Subject: Swing Check Valve Problem Reported by Palo
Verde Nuclear Generating Station

Subject: Ebasco P.O.'s NY-403458
NY-403461
Waterford SES Unit 3
A/DV S.O.'s E-6373, E-1273
4463 and 4474

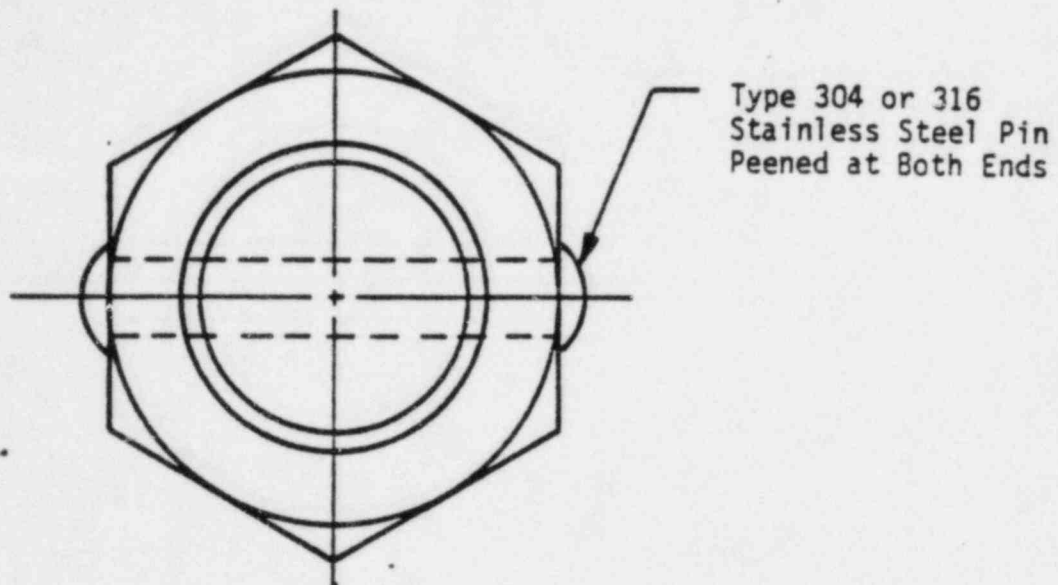
In a related problem at Palo Verde, the disc nut pin on several check valves was not lock welded as shown on the valve assembly drawing. This lock weld is necessary to retain the disc nut pin which prevents the disc nut from backing off the disc and rendering the valve inoperable. As an alternate to the lock weld, Anchor/Darling currently recommends peening the pin to hold it in place as detailed on the attached sketch.

A review of our records indicates that you may have 150 lb. and 300 lb. pressure class Anchor/Darling check valves similar to the valves at Palo Verde installed in your plant. In view of the foregoing, we recommend that you inspect these valves at your earliest opportunity and verify that the hinge pin set screws have been lock welded and that the disc nuts are retained as shown on the valve assembly drawing or as outlined on the attached sketch.

1. Nominal Pin Diameter = Nominal Hole Diameter
= 1/8 in. minimum
2. Initial Pin Length should be 1/8 in. to 1/4 in. longer than
the Nut Flat to Flat Dimension.
